Manchester Business Park, Aviator Way

Manchester City Council Comments – Applicant Response

Technical Note

Document Reference: 21347101-WAT-XX-XX-TN-N-800001_P01.01

E. Unit 4 Swept Path Analysis

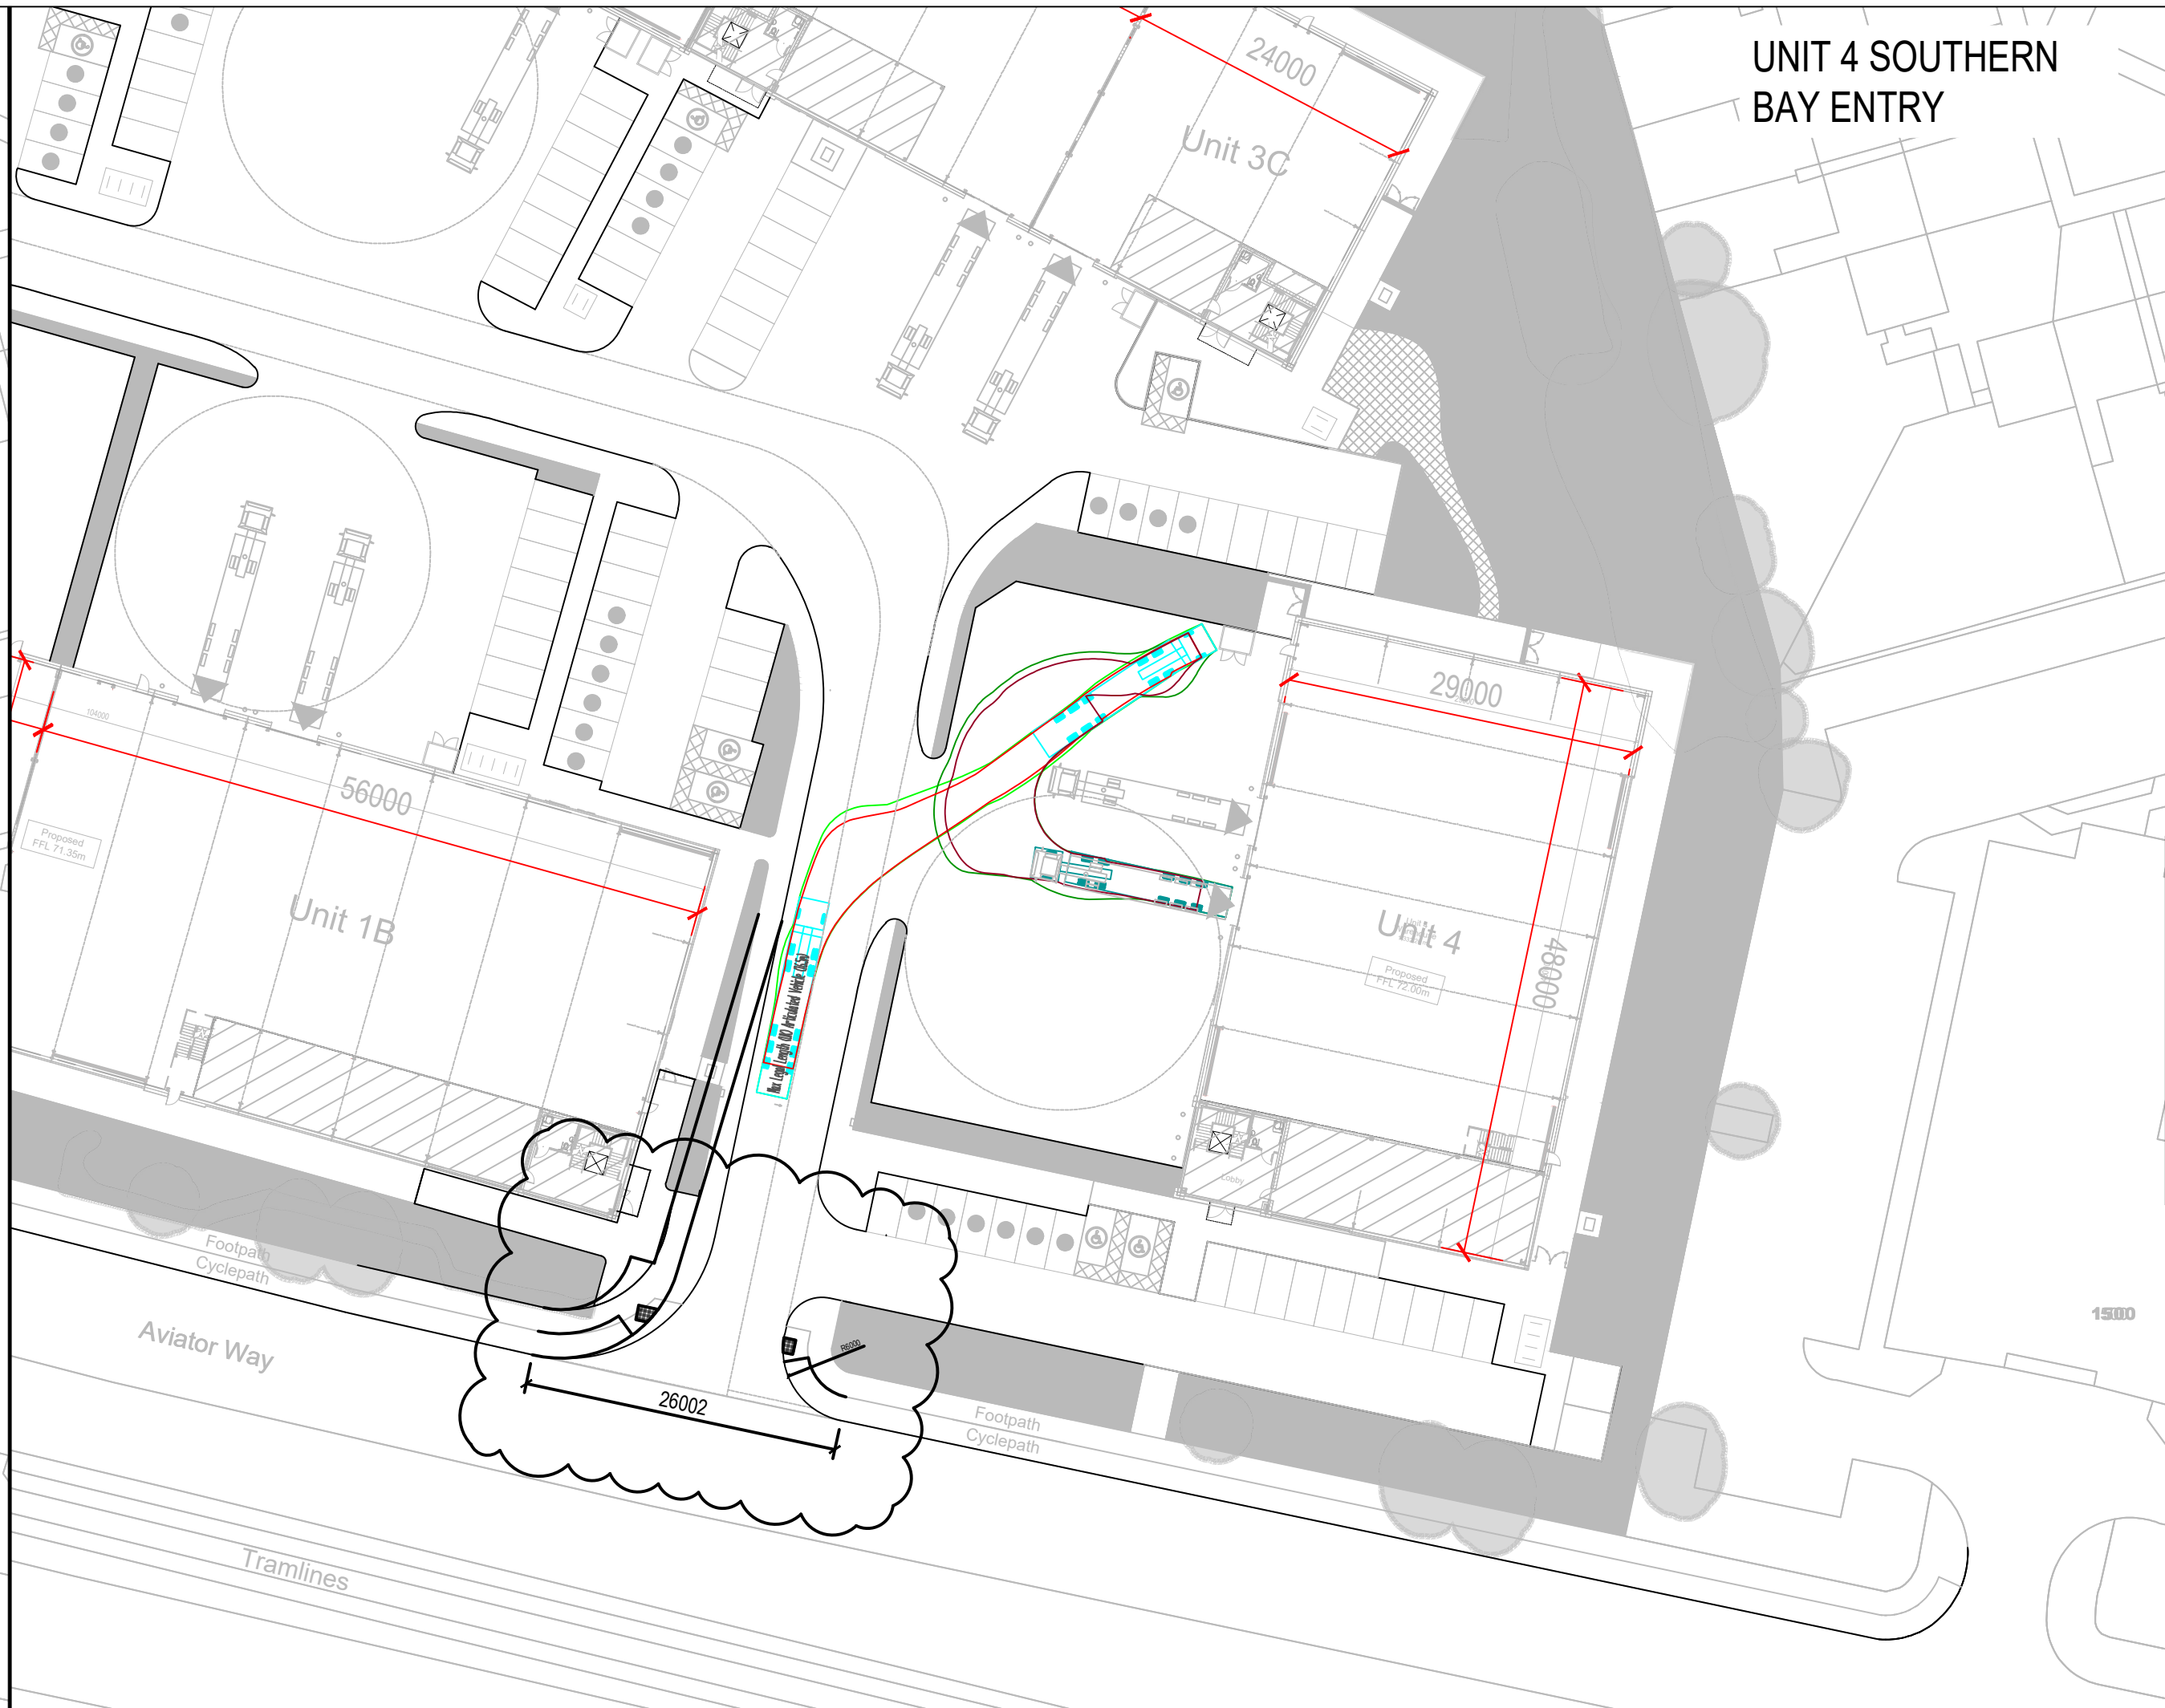
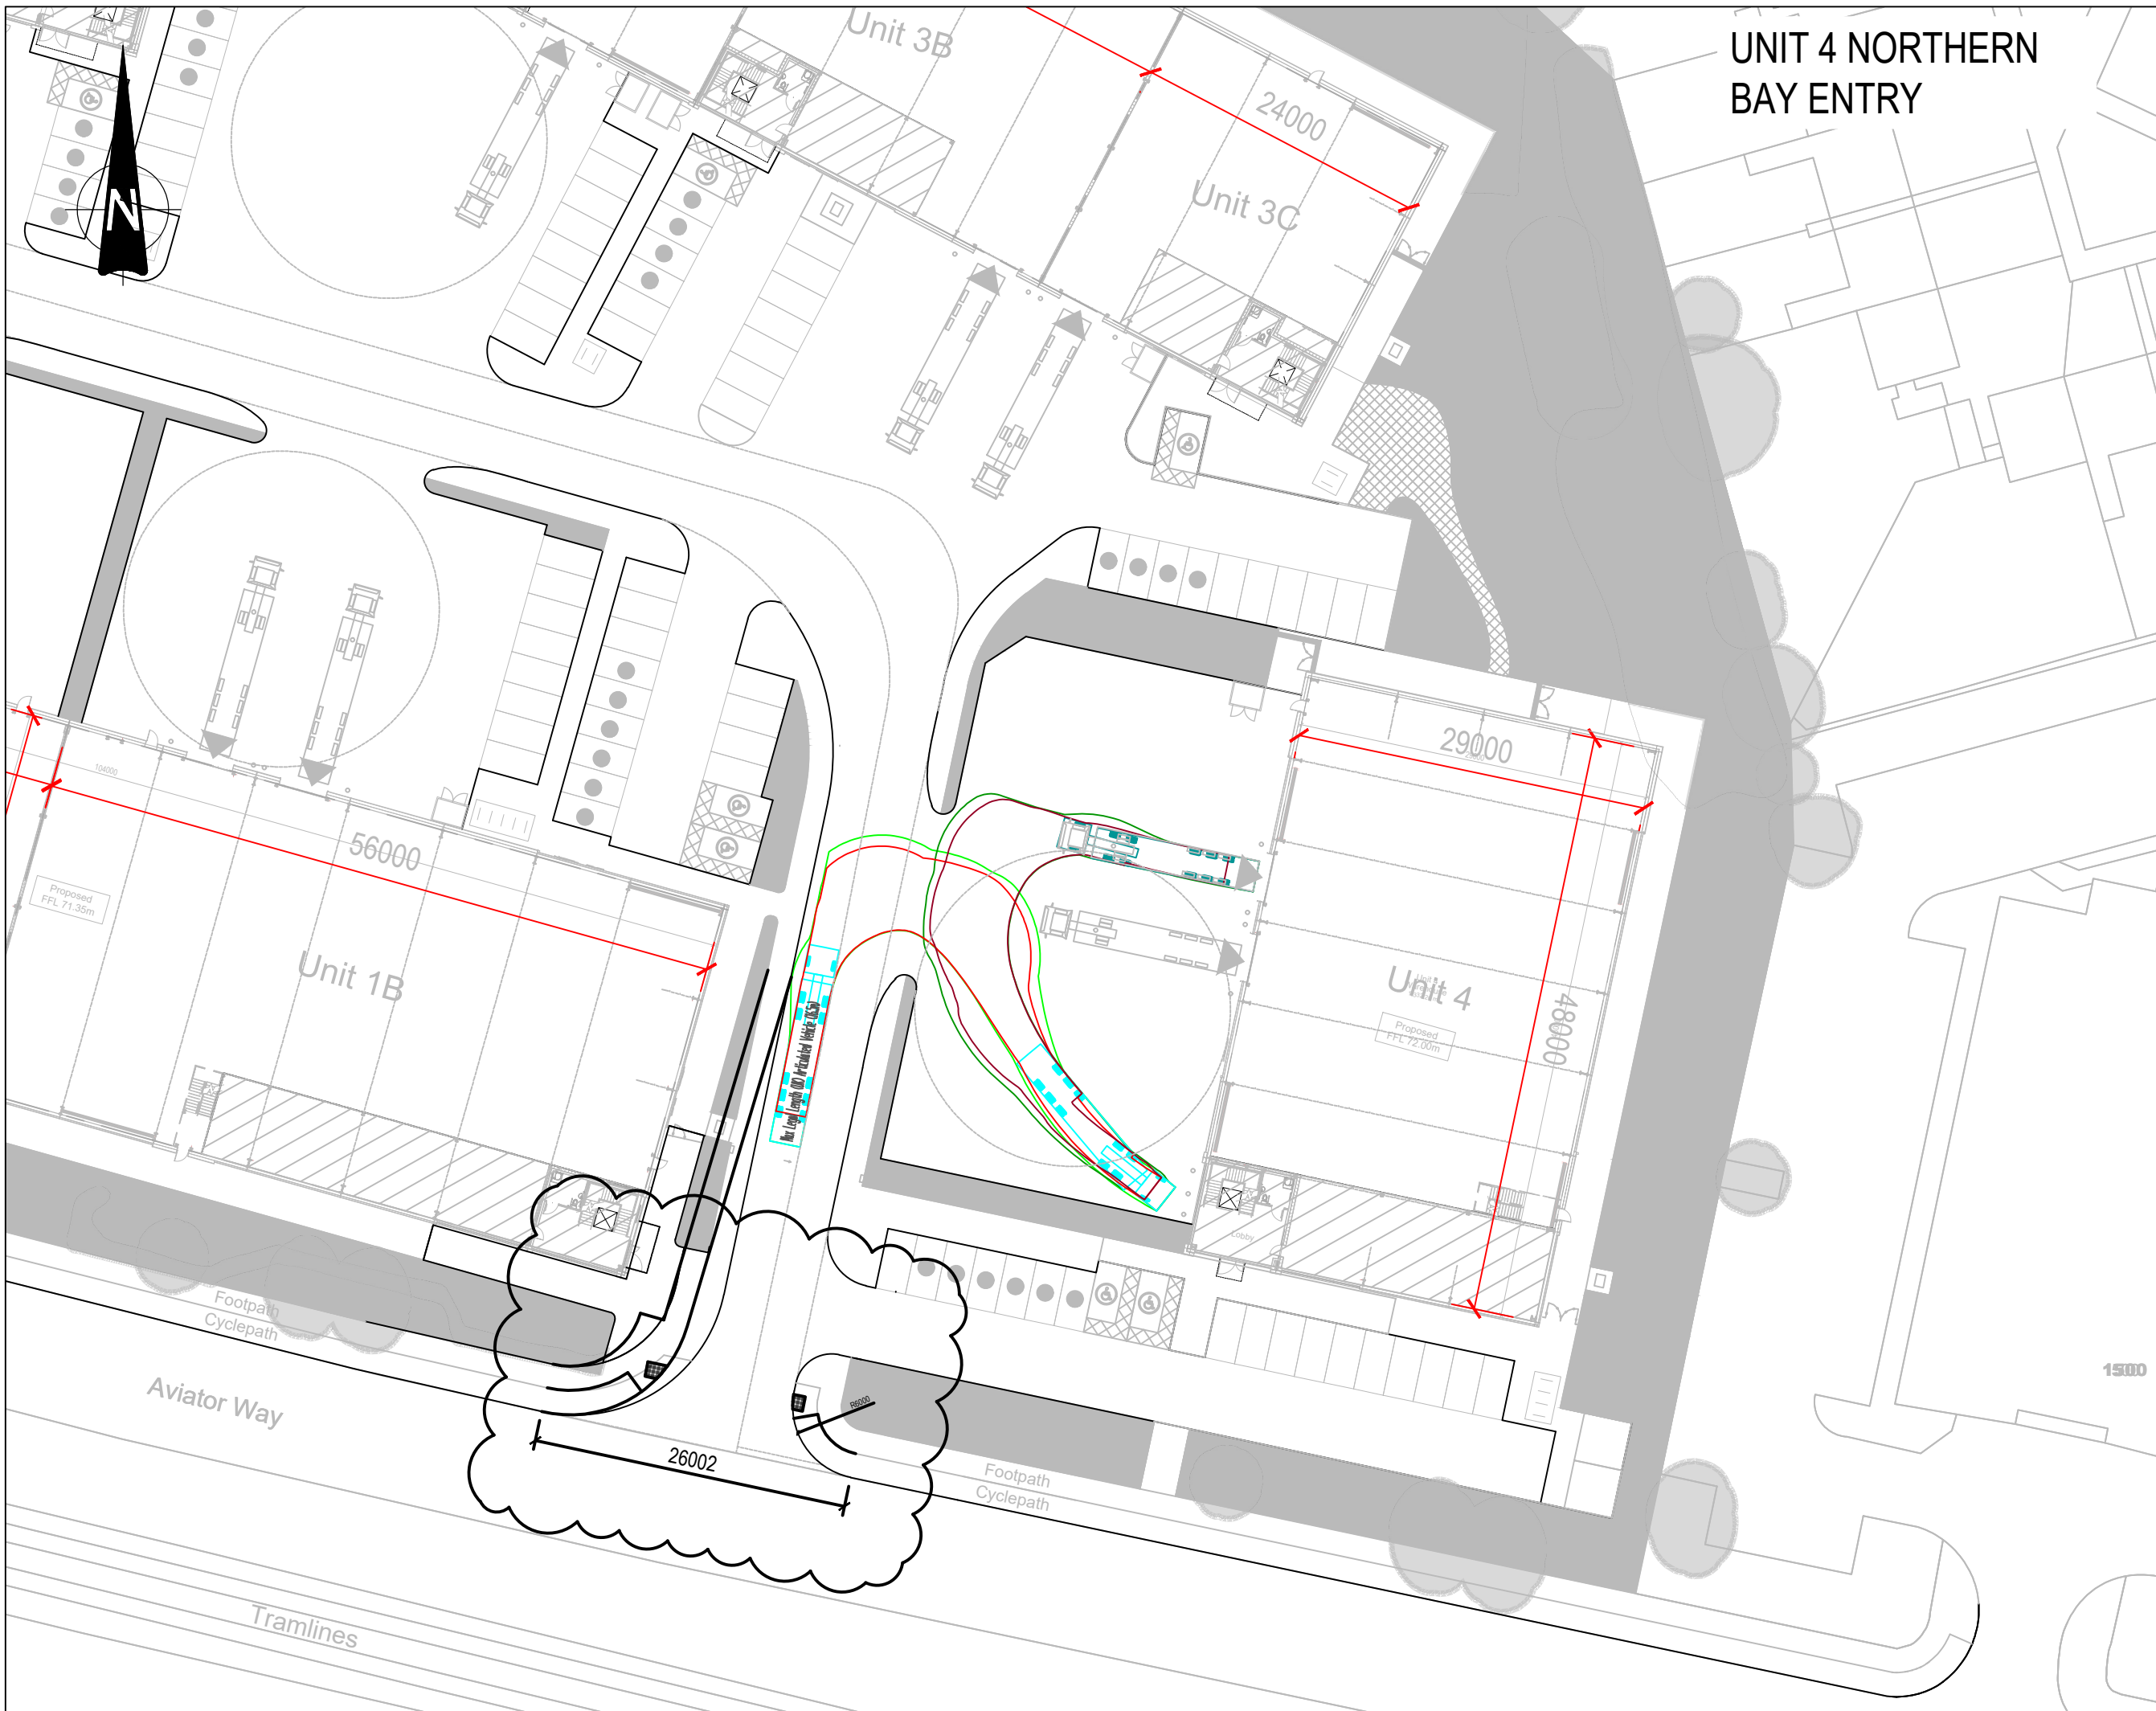
Requested that a TRICS based car parking accumulation assessment is undertaken with regards to the worst-case B2/B8 development scenario. Confirmation is sought on car parking dimensions and aisle width. This should be shown on an updated dimensioned plan.

- 2.11. The proposed parking provision is based on the Manchester Local Plan Core Strategy Car Parking Standards and is policy compliant. A TRICS based parking accumulation exercise has been conducted for each Unit, based upon the trip generation forecasts presented within the submitted Transport Assessment, and the maximum occupancy and number of available spaces for the 'worst case' B2 land use is presented in [Table 1](#) below.

- 2.12. [Table 1](#) illustrates that ample parking capacity is provided to accommodate the forecast demand in the 'worst case' B2 land use scenario for each Unit. Parking demand will be monitored and managed through a vision-led approach and travel planning measures delivered as part of the supporting Travel Plan.
- 2.13. Car parking space dimensions proposed are standard 2.5m x 5.0m bays, served by minimum 6.0m aisle widths. Disabled parking bays are 3.6m x 6.0m, inclusive of the marked buffer area.
- 2.14. A dimensioned parking plan and full parking accumulation summary tables for B2 and B8 land uses are provided at [Appendix D](#).
